# City of Alexandria, Virginia

## MEMORANDUM

**SUBJECT:** REVISED PLANS for 700-710 NORTH WASHINGTON STREET  
BAR 2015-0026 and BAR 2015-0027

BRICK CORNICE DETAILS

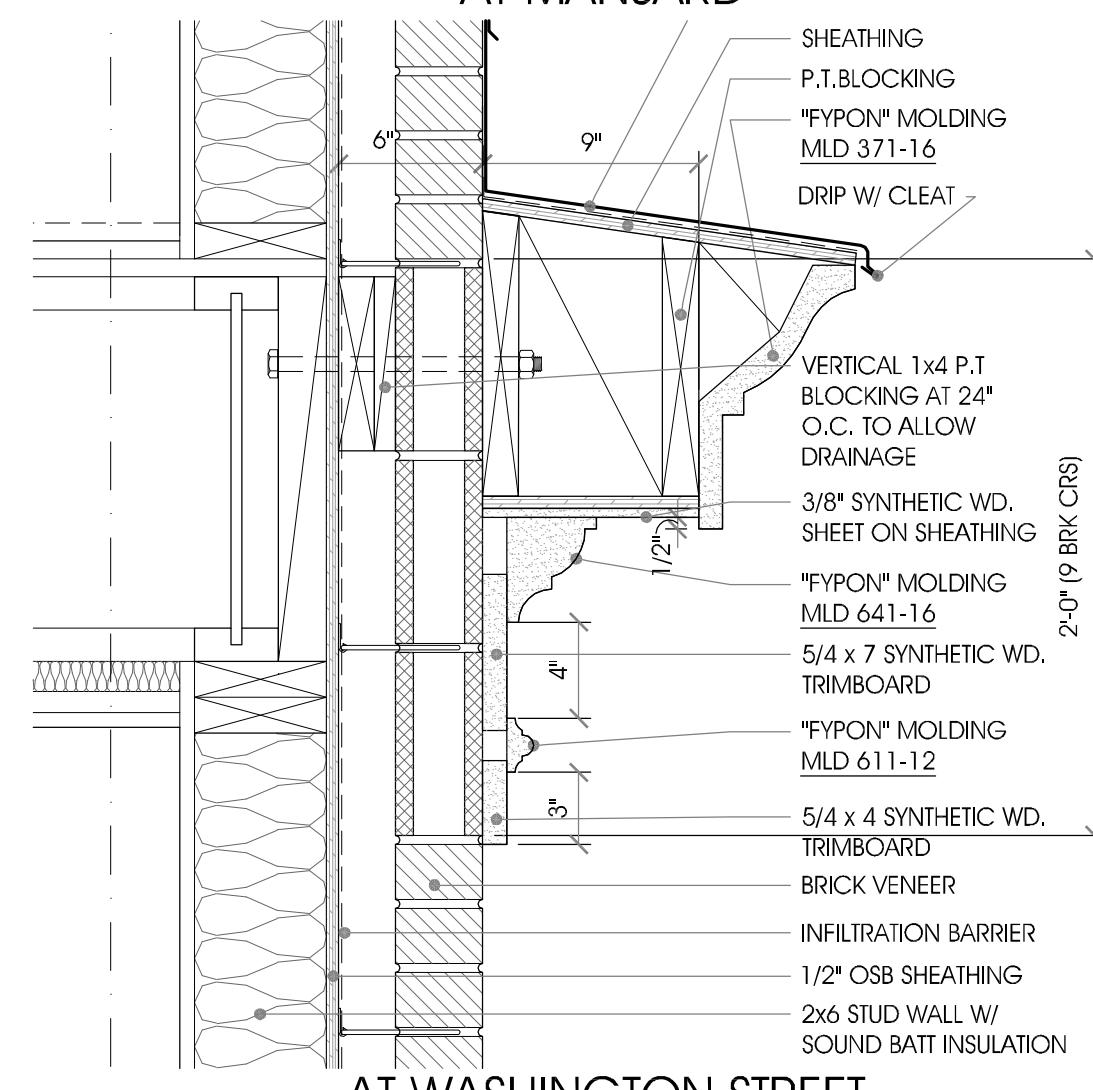
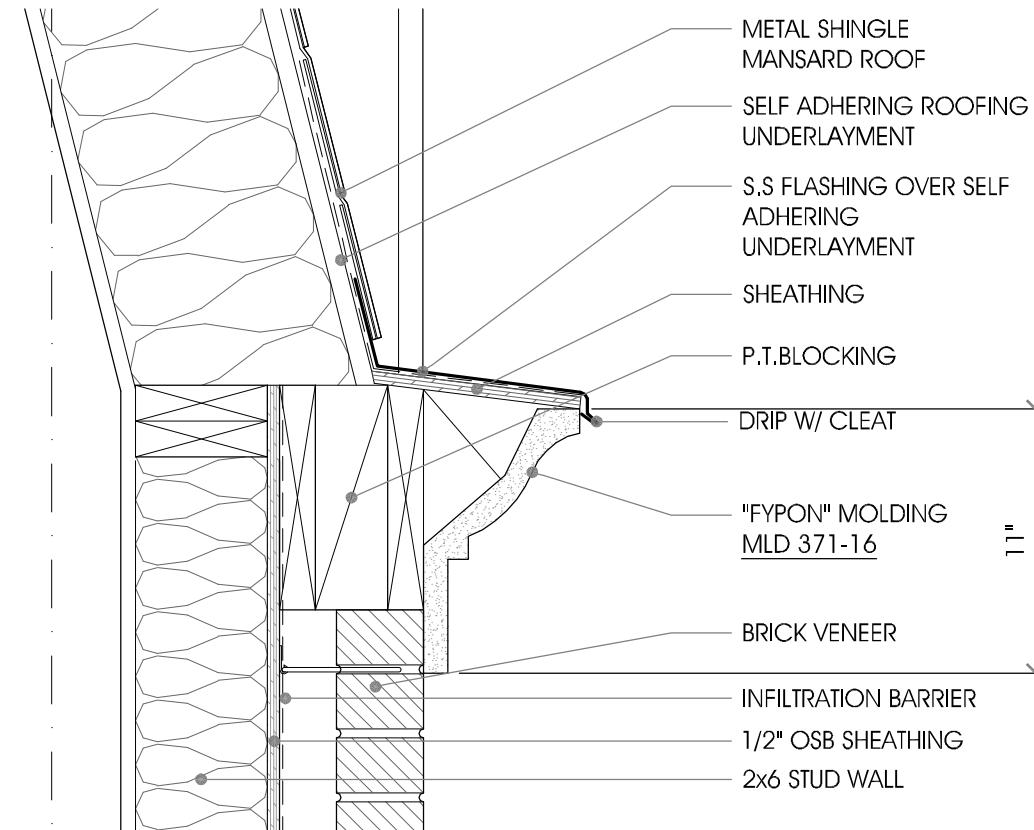
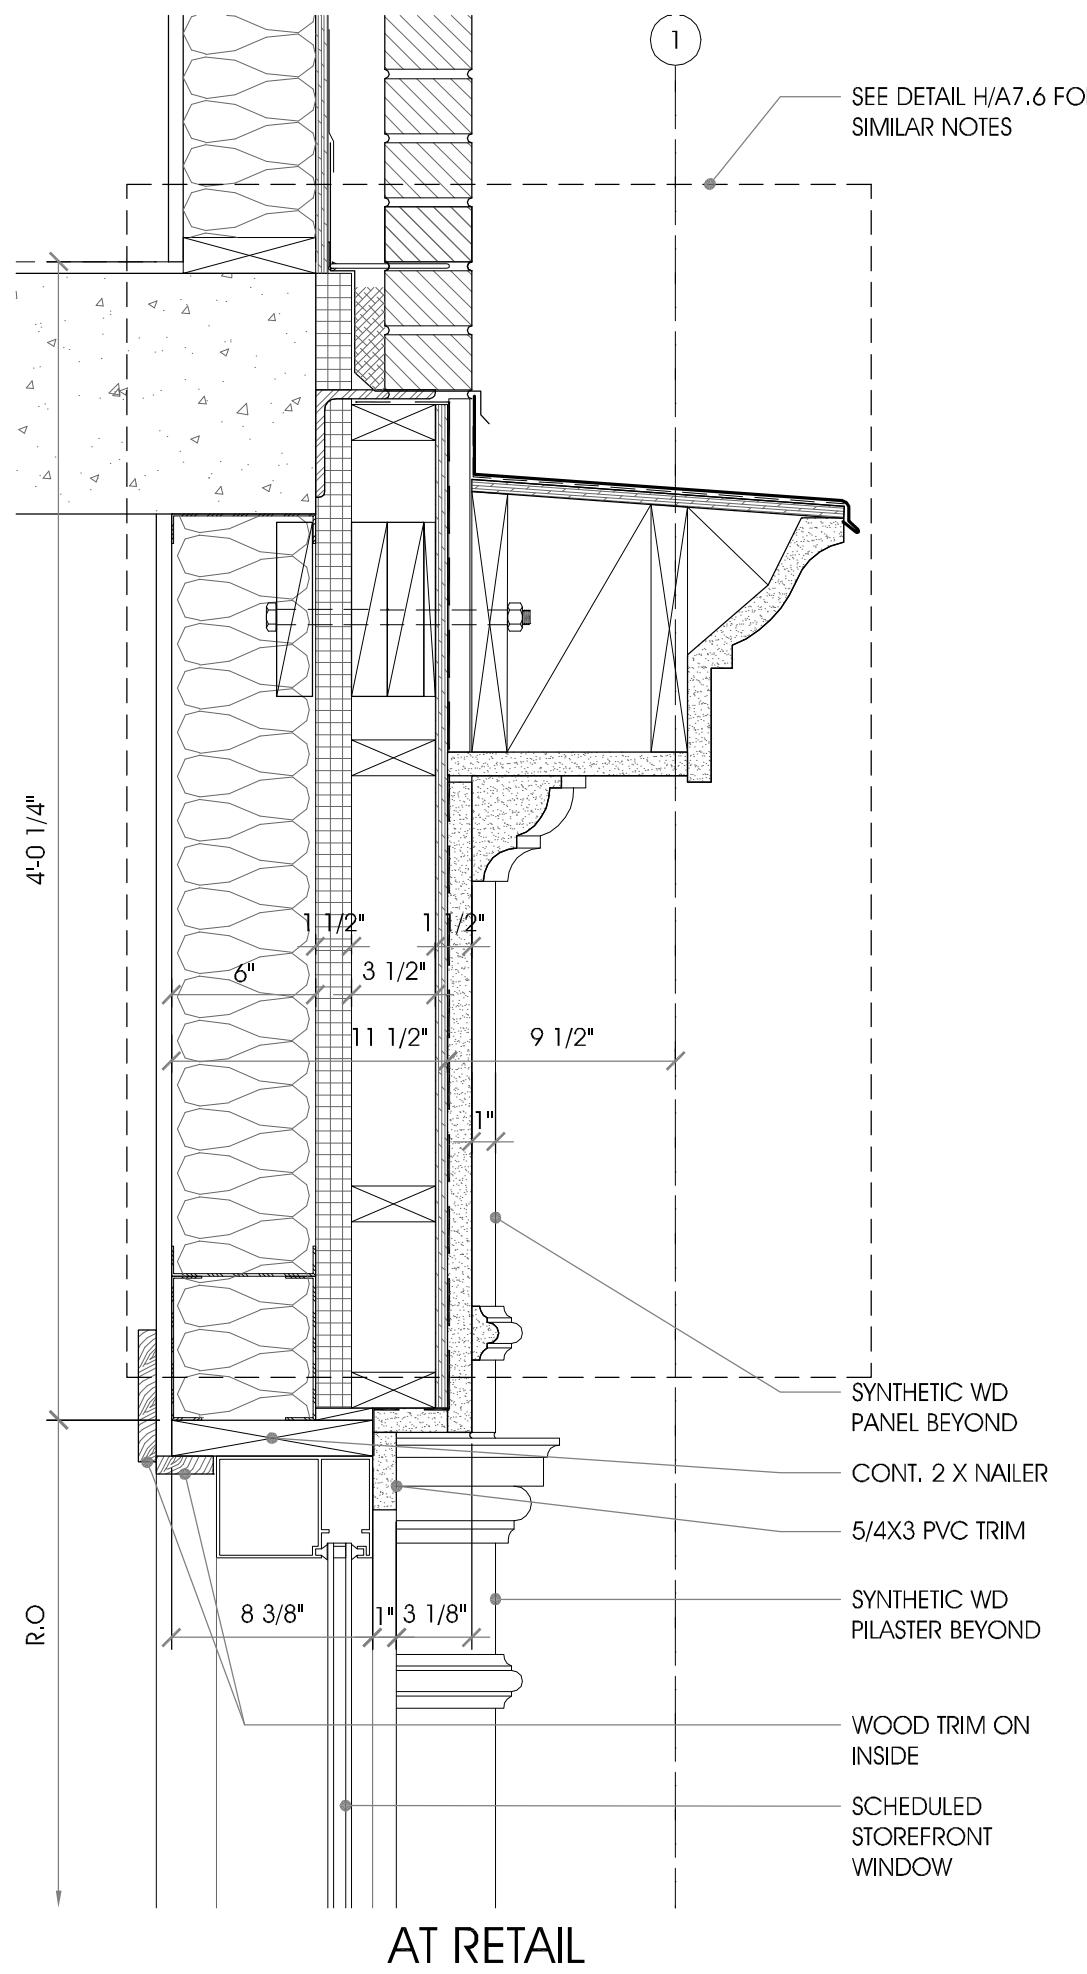
Condition 2. The applicant shall submit enlarged details and sections for elements such as corbelling, cornices, ornamental trim and the like for final approval by staff as part of the building permit review process.

Response 2. Cornice, corbelling and other details for decorative elements have been included in the submission.

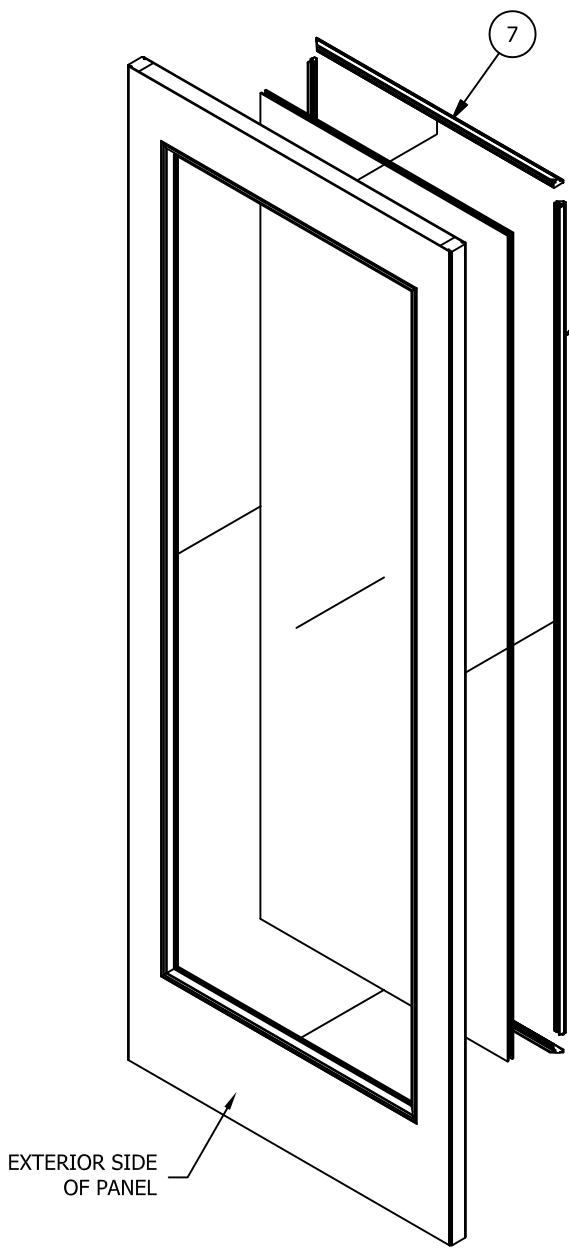
The one element which the applicant did not yet significantly revise for this submission is the rear elevation. Instead, the applicant included schematic 3-D renderings which compare the massing of the original rear elevation shown during concept review to the current proposal (Figure 1). The 3-D models provide a better sense of the changes to the overall massing—the reduction in floor area and mass—as a result of the revised rear elevation that was unclear with the last submission which only showed elevations. Please note that these renderings do not reflect the actual colors and the applicant will, again, bring samples to the BAR hearing for review. Staff supports the proposed rear elevation, as noted in the previous report, finding it preferable to the concept scheme which featured an extensive mansard roof but notes that there may be opportunity for refinement based on the BAR's comments. The general direction for refinement should be to work on relating the rear elevation to the architectural program on the Washington Street and Wythe Street elevations without creating a false historicist, high-style rear elevation. Rear elevations on buildings generally have a less formal composition and simplified details.

Some BAR members were concerned that the proposed changes to the rear elevation appeared disjointed and not as formally organized as the version shown in the concept review. The 3-D massing model illustrates that the revised rear elevation actually reduces the physical mass of the rear as one large massive building (previously united with a continuous mansard roof) and better reflects the three “building” typology design of the front elevation. This change also reflects a reduction in overall floor area and increased setback from the alley and St. Joseph's Church.

Some further refinements will enhance this distinction of three different buildings on the three to better relate to the overall concept of the project. Revising the rear color choice—elimination of the bright red elements—will help to make the rear less prominent, typical of many rear elevations. Changing some of the windows, such as adding 2/2 windows in the portions that relate to where the front of the building has 2/2 windows, will also enhance the three building character of the rear. Additionally, it is recommended that the applicant enhance the rear porches to make them more integral to the composition of this rear elevation and more stylistically related to the rest of the building. Such a scheme would emphasize the rear porches—a common element on buildings from all styles and time periods—and also provide more cohesion to this elevation. As much of the Washington Street and Wythe Street elevations derive from late 19<sup>th</sup>-century architectural styles, it may add to the understanding of the overall project to have porches also nod to such a style, either as iron metal porches or some decorative woodwork, such as a knob and spool railing. However, it should be noted that this is not a suggestion to create high-style Victorian rear porches that would look overdone and out of place.

Because the rear elevation is the only outstanding item in the BAR's comments, and because there are a few directions that could address the BAR's concerns, staff encourages the applicant to explore these refinements and to bring supplemental, clarification materials to the hearing for discussion. Although the Board strongly discourages introduction of a new design at the hearing, the applicant has shared their presentation materials with staff and the additional views and details substantially aid understanding of the design intent on the rear elevation. Such an approach should not be construed as a precedent but staff thinks that, in this case, this approach will be useful and allow the applicant time to prepare more refined graphic materials for the BAR to discuss and vote upon.
